Submissions and Preferred Infrastructure Report

Newcastle Inner City Bypass
Rankin Park to Jesmond

Newcastle Inner City Bypass – Rankin Park to Jesmond Submissions and preferred infrastructure report

Roads and Maritime, as the proponent of the project, has prepared this submissions and preferred infrastructure report to respond to issues raised in submissions and describe and assess design refinements made since the exhibition of the EIS.

Figure 5-1c
The project

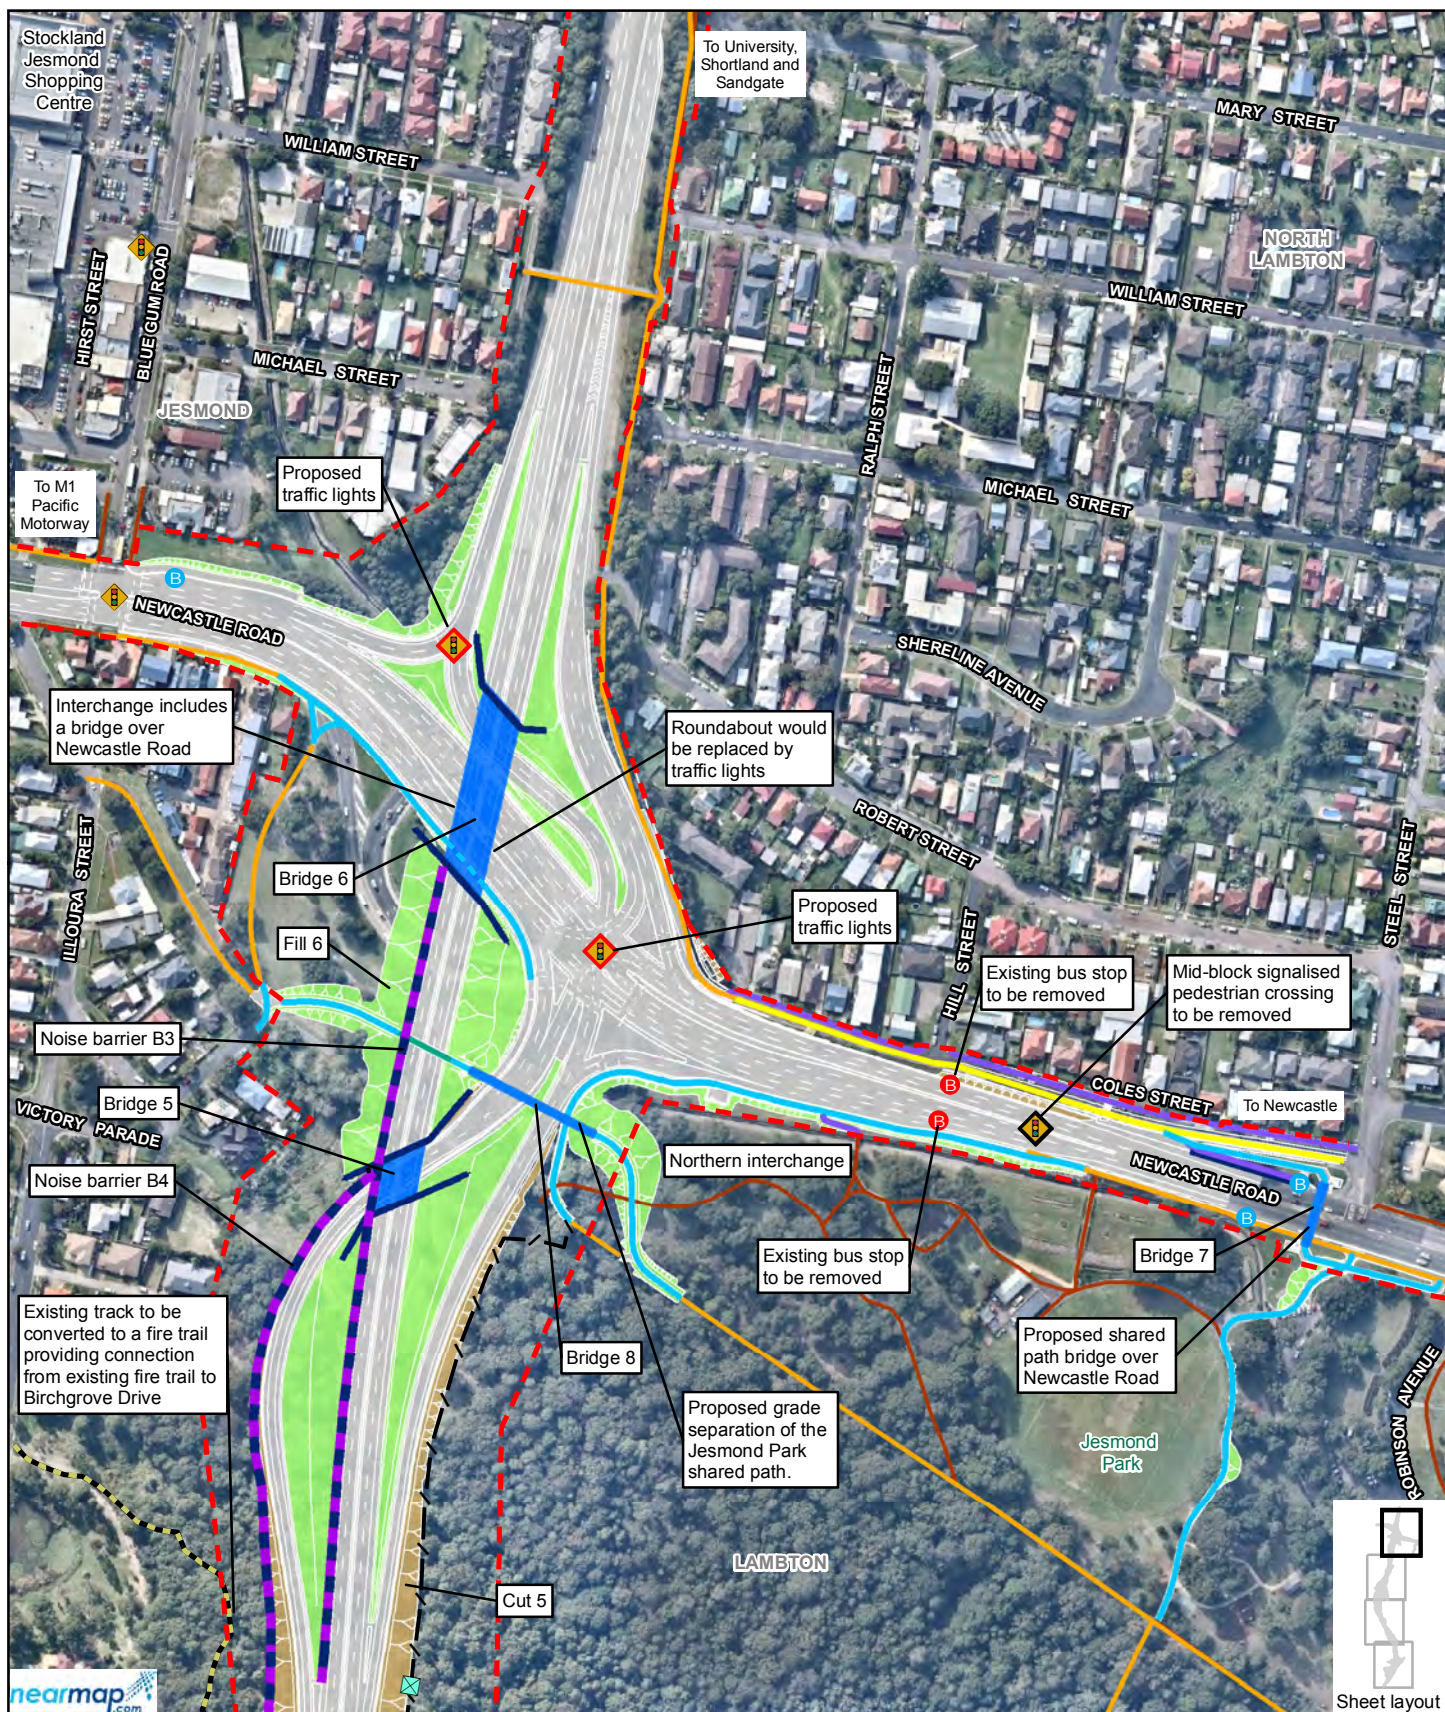
These are described in the following sections and key refinements are shown in Figure 5-1.

The key features of the project (including the proposed design refinements) (Figure 5-1) include:

To assist with ongoing water quality control during operation of the project it is now proposed to retain and modify eight of the construction sedimentation basins as operational water quality treatment structures, as shown in Figure 5-1. Vegetated swales are also proposed to be constructed along batters as operational water quality treatment structures. Vegetated swales are proposed to be constructed where batter grades are suitable (where batter grades are between one and five per cent). These structures would capture stormwater runoff from all operational areas of the project (excluding existing roads).

Figure 5-2
Hospital interchange

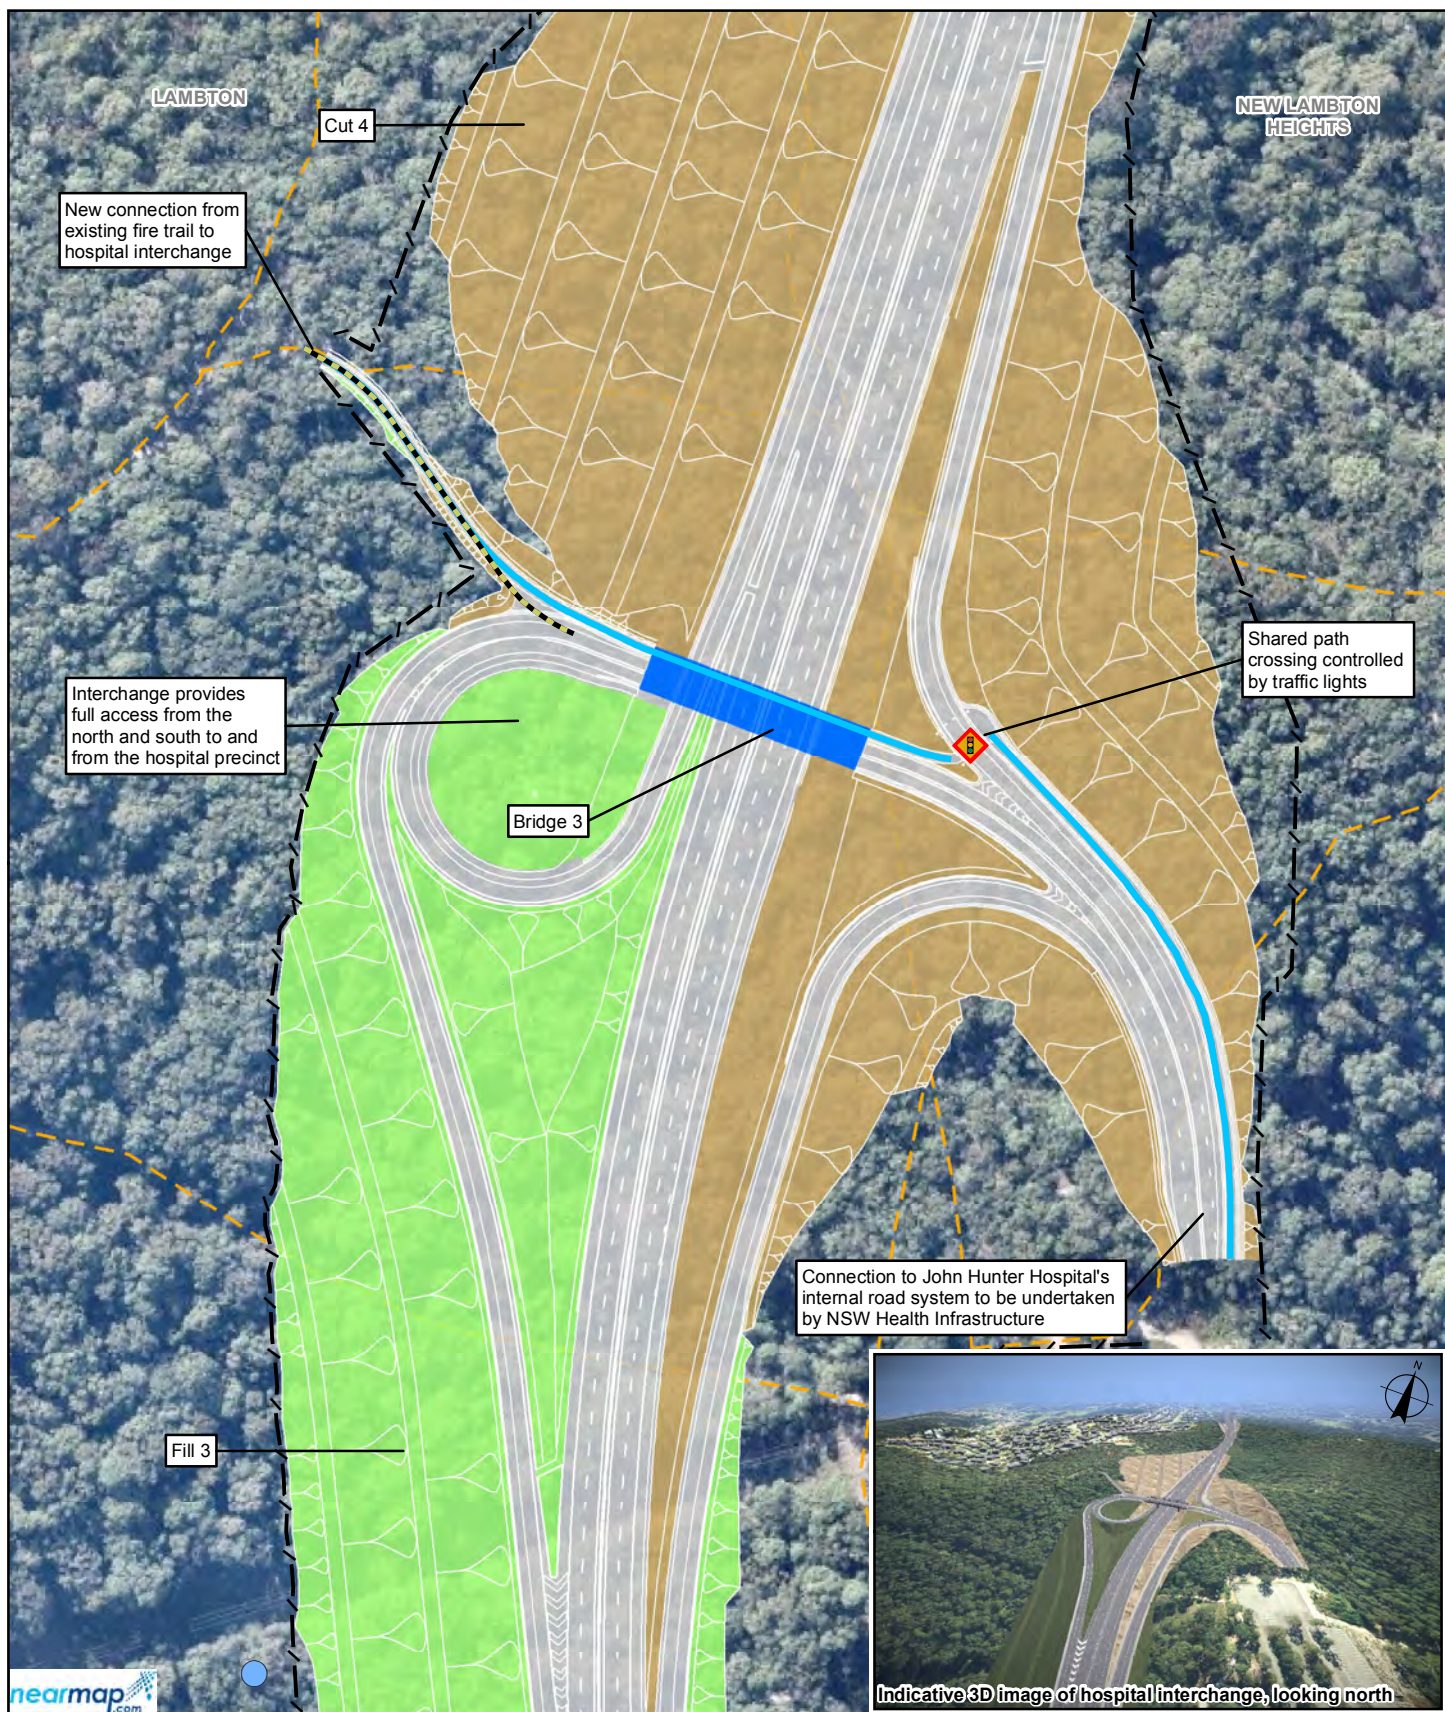
The hospital interchange would now be a full interchange with both north and south-facing ramps as shown in Figure 5-2.

The project would now provide traffic lights at the crossing point for use by pedestrians and cyclists as shown in Figure 5-2 so pedestrians and cyclists do not need to give way to vehicles.

Figure 5-3
Jesmond Park shared path grade separation

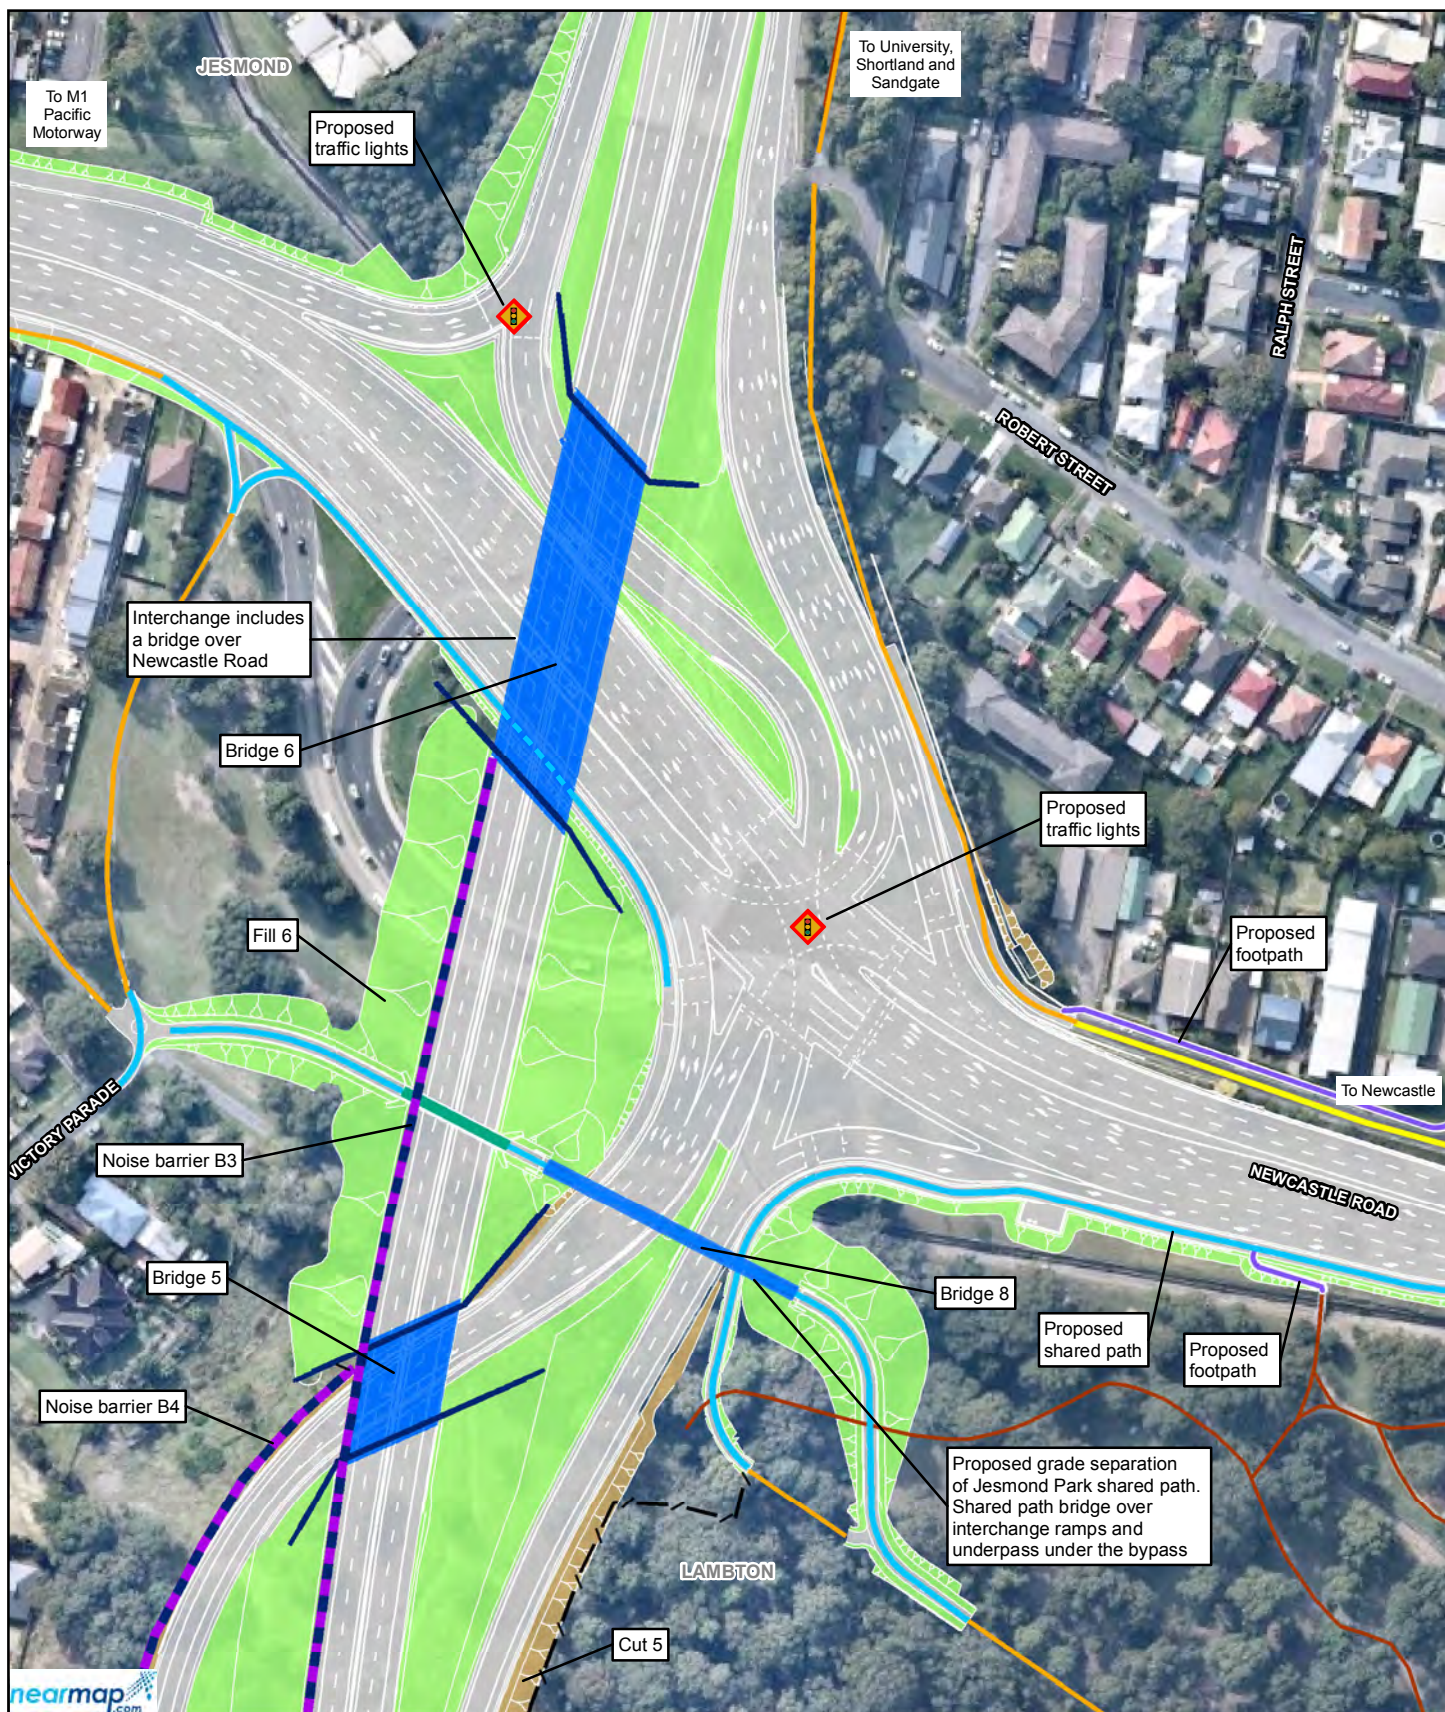
The project would now provide a grade separated shared path consisting of an overpass bridge (Bridge 8) and underpass arrangement, which would connect with existing shared paths as shown in Figure 5-3.

This means pedestrians and cyclists do not need to cross the project via traffic lights for east-west movements. This would provide access to the Newcastle Road and Blue Gum Road intersection via Illoura Street. Refer to Section 5.5.1 for further information regarding the design of the overpass bridge and underpass arrangement.

Figure 5-4
Bridge 8

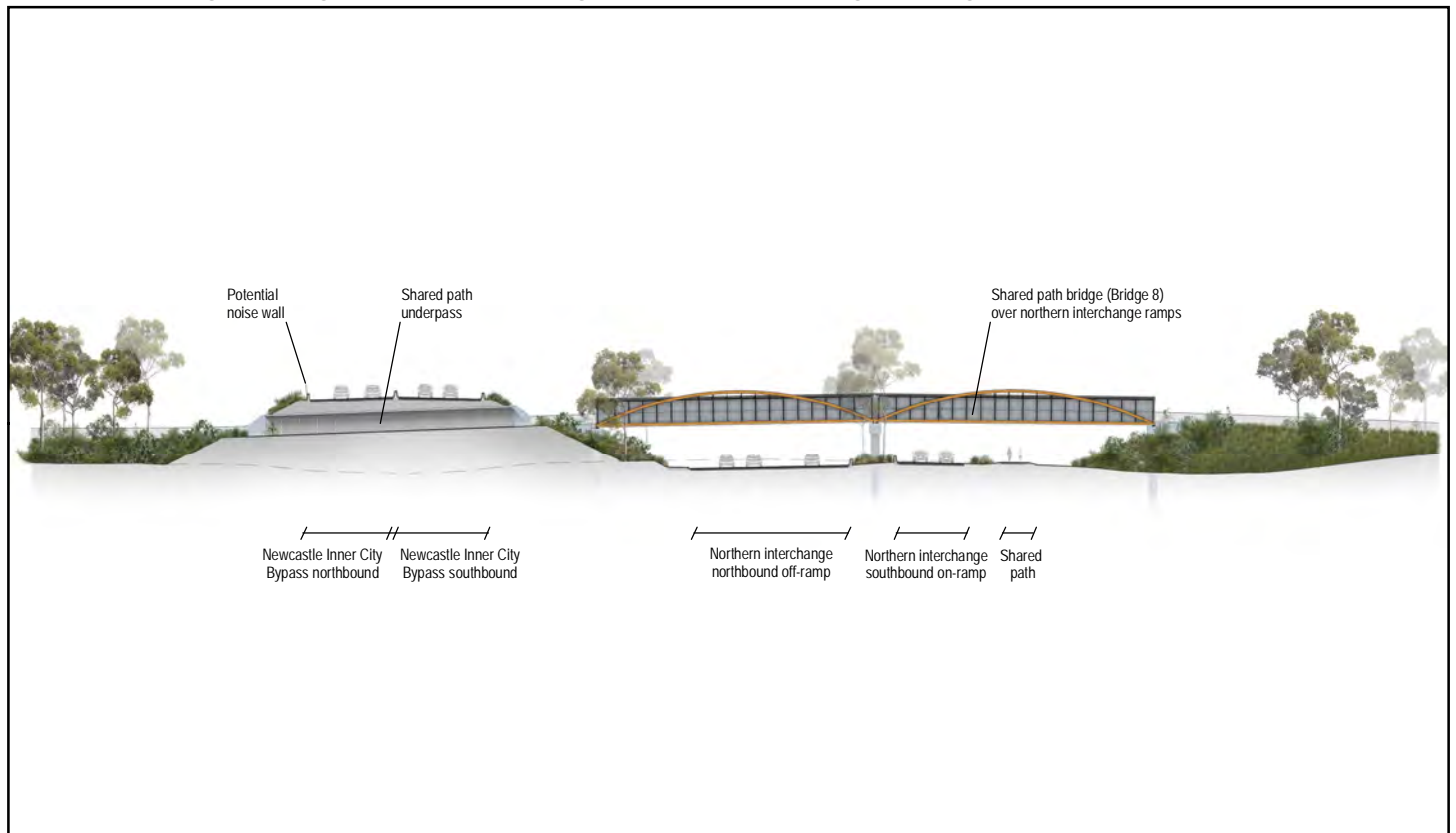
The new Bridge 8 (Figure 5-4) would be a two span steel arch structure and about 77 metres in length. One support pier would be located between the northbound off-ramp and southbound on-ramp.
